Landscape Referral Response

| Application Number: | DA2024/0774 |
| Proposed Development: | Construction of a dwelling house including swimming pool |
| Land to be developed (Address): | Lot 1 DP 1086858 , 6 Mitchell Road PALM BEACH NSW 2108 |

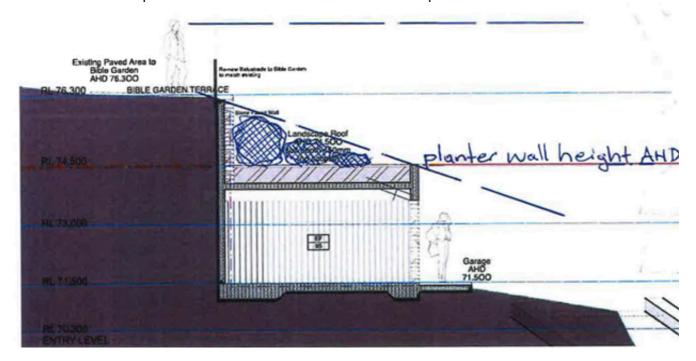
The development site adjoins the locally listed heritage item identified within the Pittwater Local Environmental Plan (PLEP) as "The Bible Garden". Physically the development lot and the Bible Garden are separated in the majority by landform elevation including large rock ledges. Existing trees and vegetation within the Bible Garden shall be protected and tree protection fencing shall be required as imposed by conditions to the two existing Pinea pinea (Stone Pine) during excavation works for the new retaining walling at the Bible Garden boundary. As identified in the Parks Reserves and Foreshores Referral, the impact to existing landscape elements within the Bible Garden are unknown as the proposed retaining walling has not accounted for over excavation.

The submitted Landscape Plans are conceptual in intent and there are components that require further clarification or amendment. The rooftop planter shown on the MasterSet Plans is at AHD 74.50 for the highest planter and at AHD 73.600 for the lower planter. The maximum permitted development height is AHD 74.500 such that the higher planter with soil and walling at AHD 74.500 is already at the maximum height and thus the proposed planting is required to, either not be taller (requiring reduced soil depth) or designed to appreciate the view angle as shown in the figure below, and detail layout and sections are required to be submitted to illustrate this on all plans.

Clearly the planter walling at AHD 74.50 presents the limits that as viewed from the Bible Garden, no planting should be over the view angle. To preserve the views from the Bible Garden, conditions will be imposed that at all times the edge of the planter walling at AHD 74.500 shall be visible, and any introduced planting or windblown planting shall also be maintained to be restricted to this height in perpetuity.
